**TENDER 16-20**  
**WATER TREATMENT BUILDING**

**ADDENDUM NO. 2**

**September 23<sup>rd</sup>, 2016**

**Addendum Item 1**  
**Questions & Answers**

TITLE: PROPOSED RAW WATER SUPPLY MAIN HIGHWAY #28 TREATMENT BUILDING - CONTRACT 2 PLAN AND PROFILE - ACCESS ROAD	DRAWING NO. 15-508- C101 PROJECT: 112311316 REV. 2
--	--

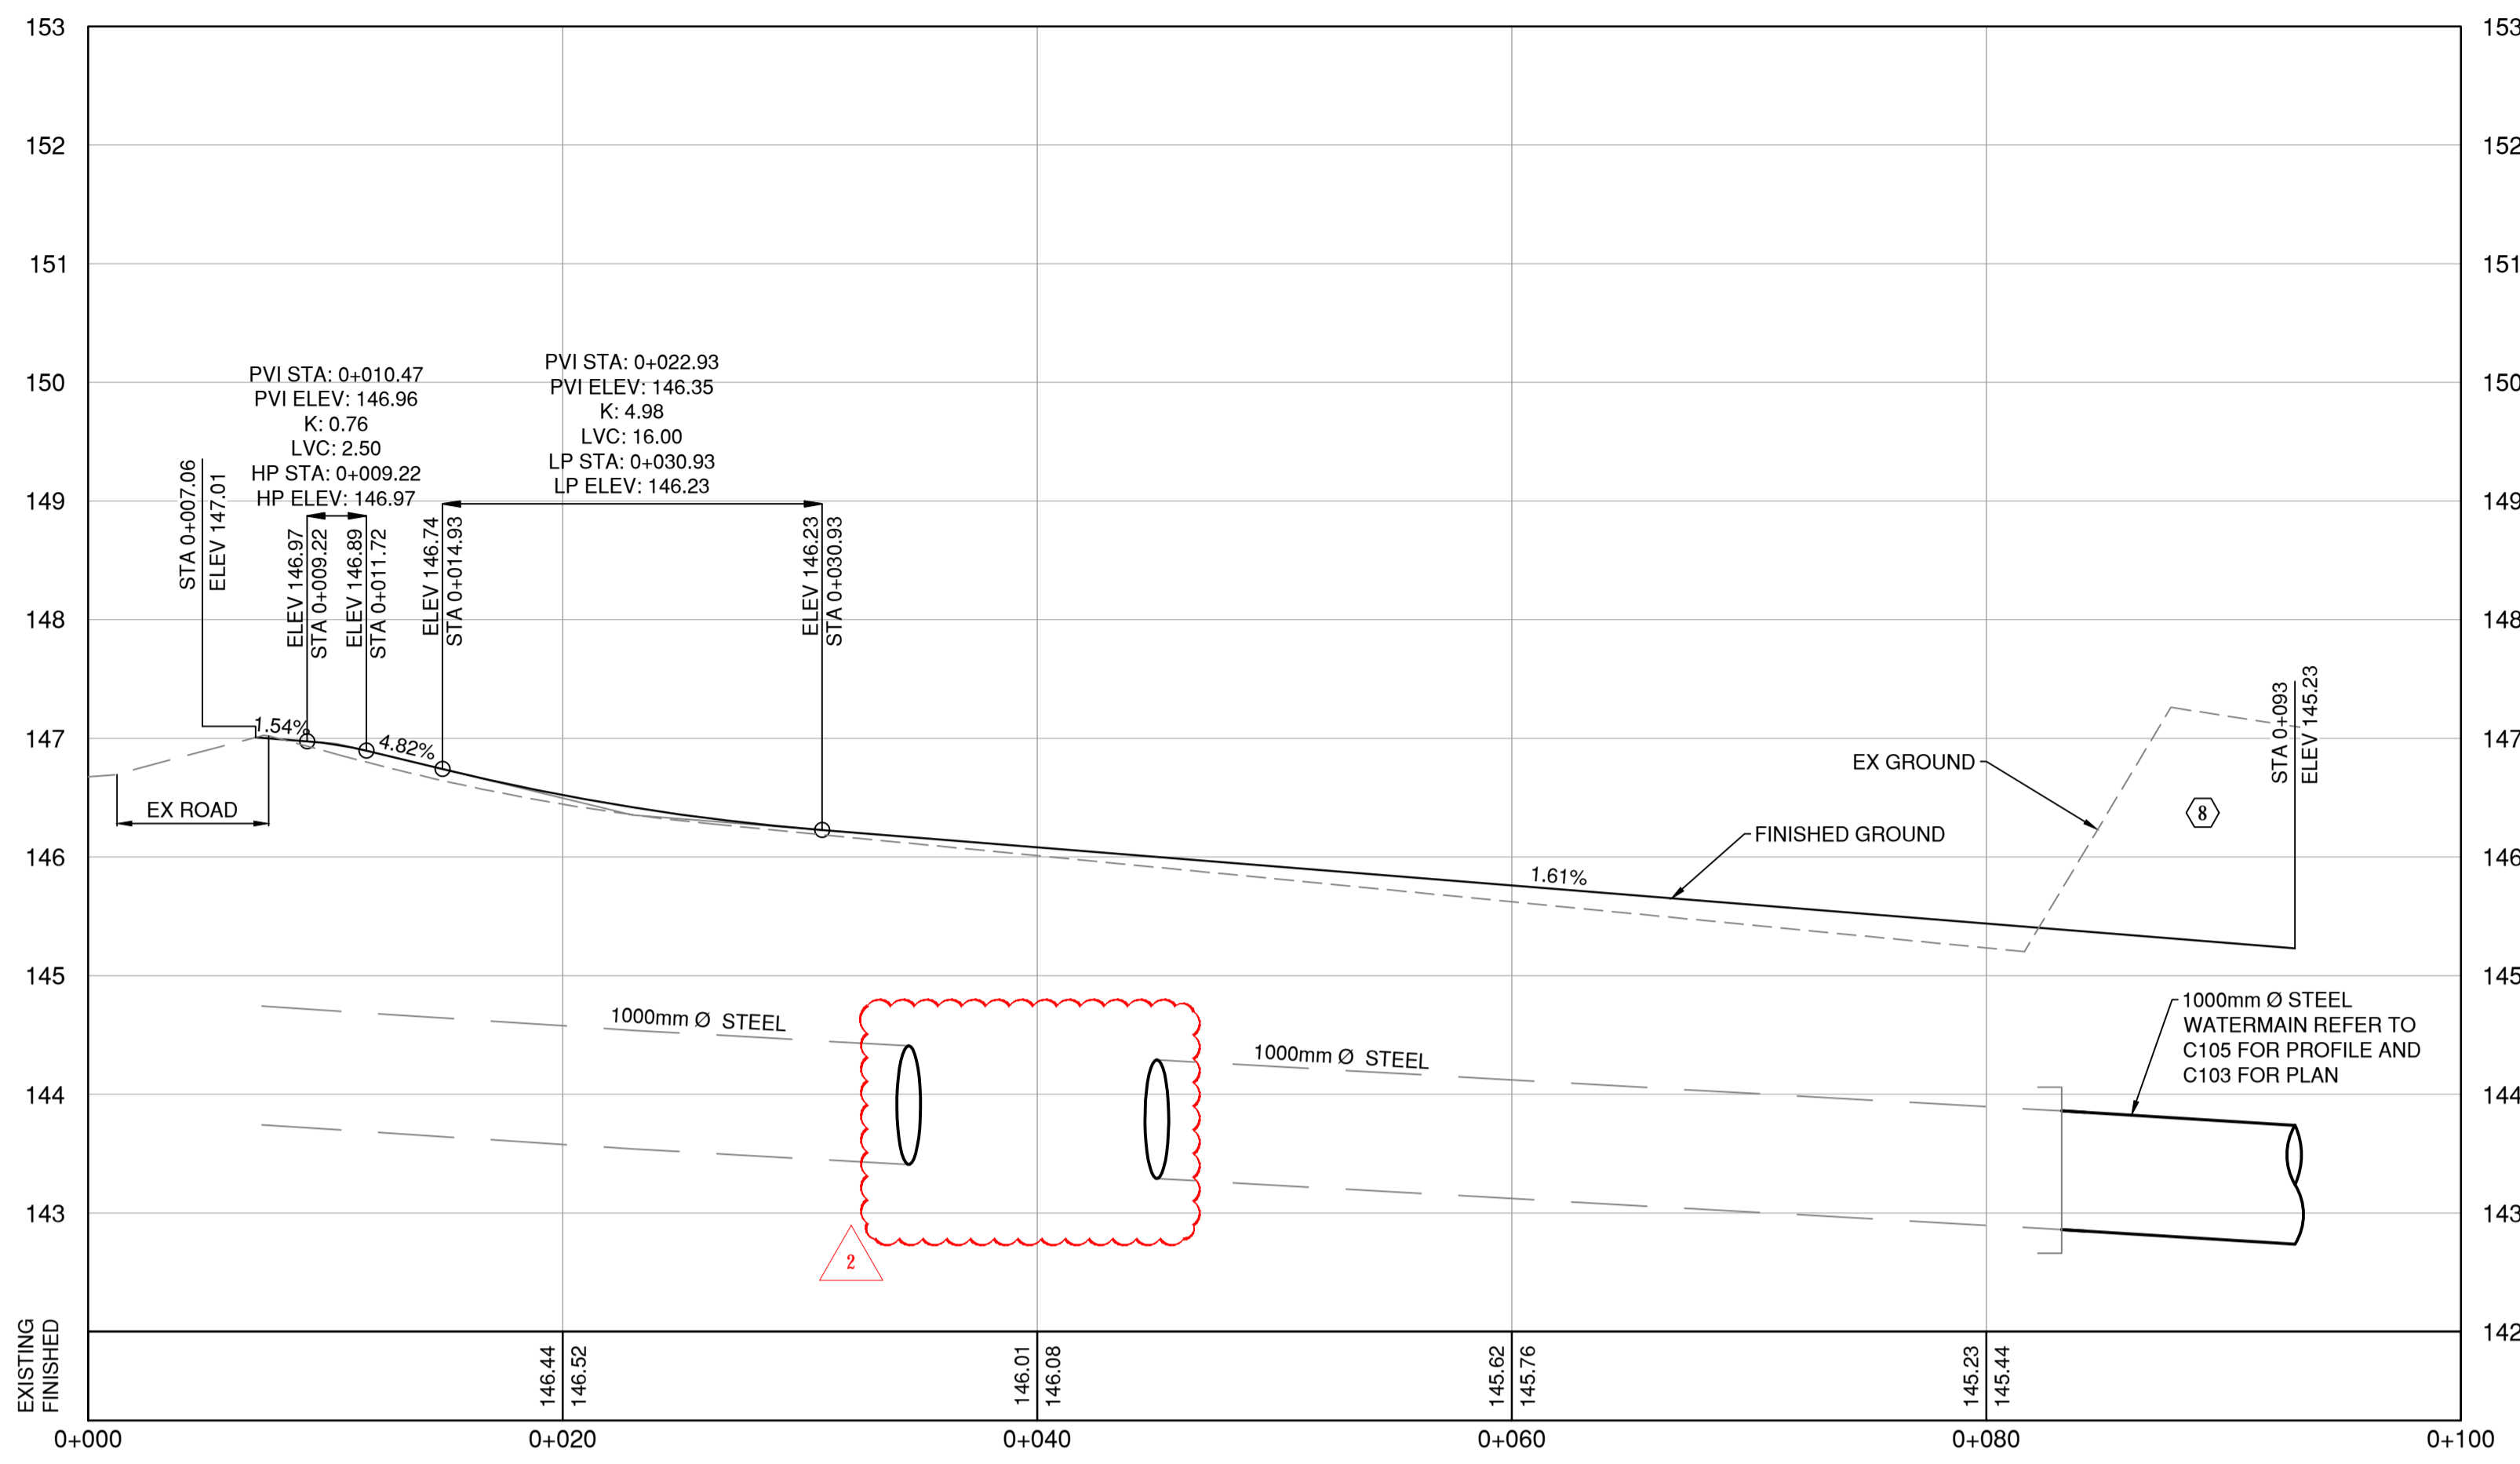
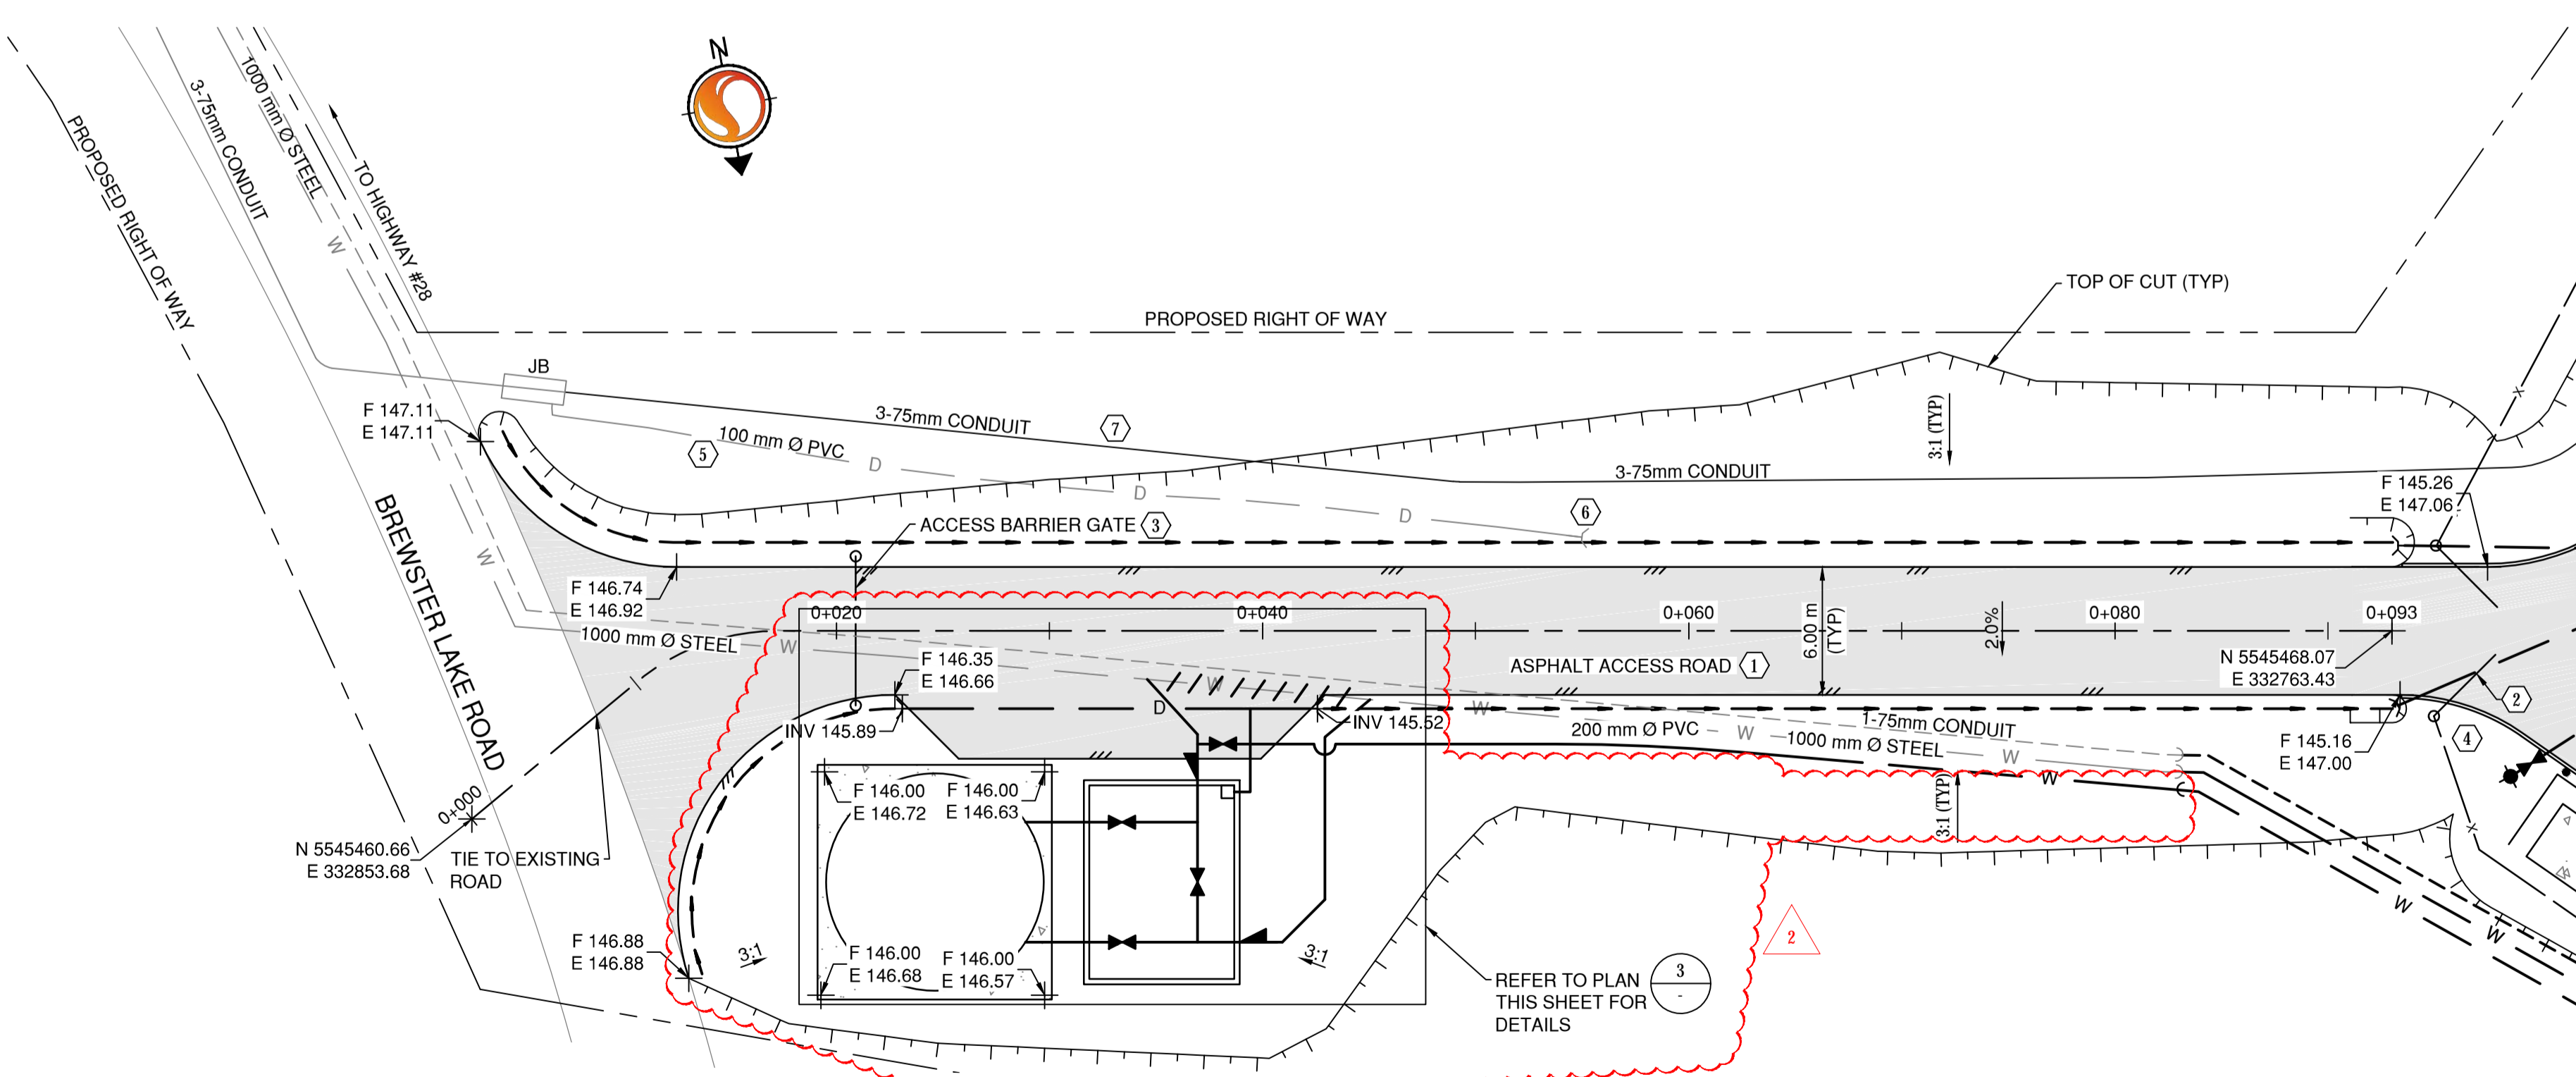
- a. S102, 105, 106 are structural drawings relating primarily to grating and trench details in the building.
- b. C201, C105 are clarifications as pipe is not owner supplied.
- c. C101, C305, S110 and S111 have been revised and/or added to the set to detail out surge tank details and the associated valve chamber.

- ⑨ REMOVE 1000mm Ø PIPE AS SHOWN
- ⑩ CONCRETE VALVE CHAMBER. FOR DETAILS REFER TO C305 AND STRUCTURAL.
- ⑪ 10.2m Ø STEEL SURGE TANK. REFER TO SPECIFICATIONS DETAILS. DETAIL CONNECTION INFORMATION TO FOLLOW IN ADDENDUM 3
